ADVANCE NOTICE OF REVISION

Section V: Elevator Assembly

Figure A: Trim Tab Control Horn Dimensions for Electric Trim

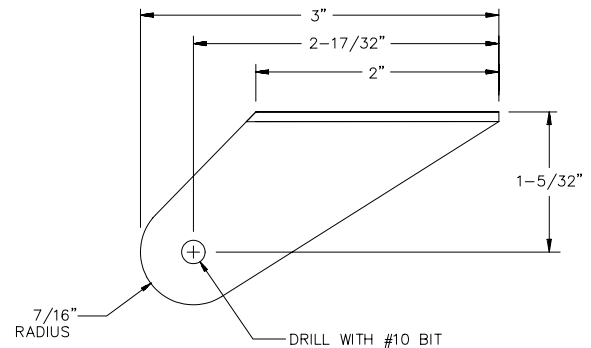
Pages 75–75.2: The text and illustrations for Step 61 will be changed to specify that the trim tab counterweight is necessary for **manual trim installations only**. Builders installing electric elevator trim may omit all work involving the **trim tab counterweight arm** (Key No. 23). Because the counterweight arm will not be installed, builders using electric trim may also fabricate their trim tab control horn per the dimensions in Figure A, rather than those given in manual Figure 39.1.

Page 175: Figure 94 will be replaced with this figure.

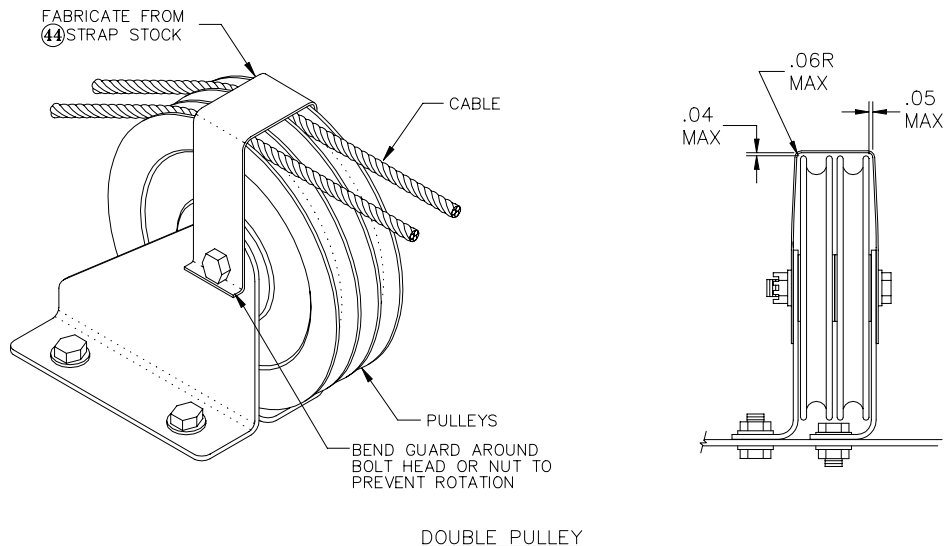
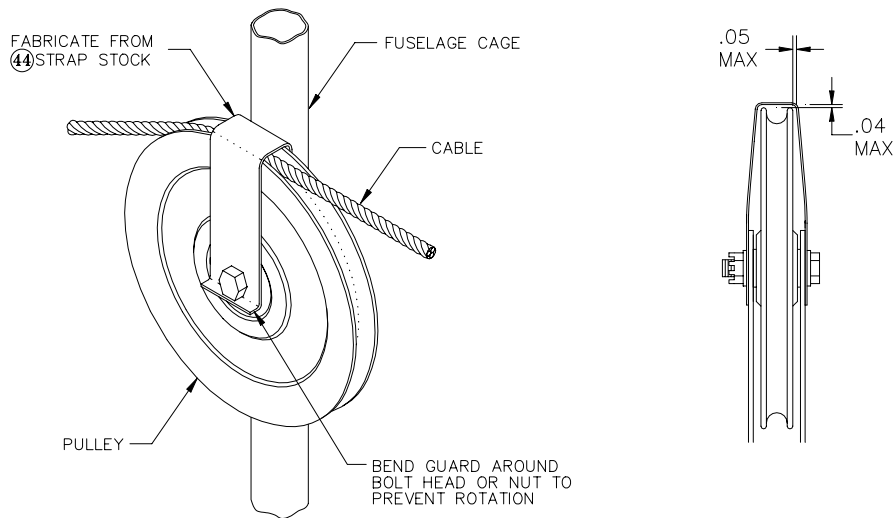
Page 172: The highlighted note will be changed to read: Each cable guard using cotter pins, clevis pins or other welded structure must not exceed a maximum clearance of 1/16" from the edge of the pulley to effectively retain the pulley.

Step 48: The second paragraph will be changed to read as follows: Fabricate guard straps for the remaining pulleys from the supplied cable retainer strap stock [44], as shown in Figure 94. Bend the guards over a wooden or metal form block with a maximum corner radius of 1/16" using a plastic or hard rubber mallet. For guards that fit over a single pulley, use a form block that measures .48"; for guards that fit a double pulley, use a .96" form block. To Drill the holes for mounting the bolt, clamp the strap over a wooden block, and use a drill press to drill through both legs of the strap and block all at once. In all cases, make sure the finished guards meet the clearance limits as shown in Figure 94. Deburr and corrosion-proof the finished straps.
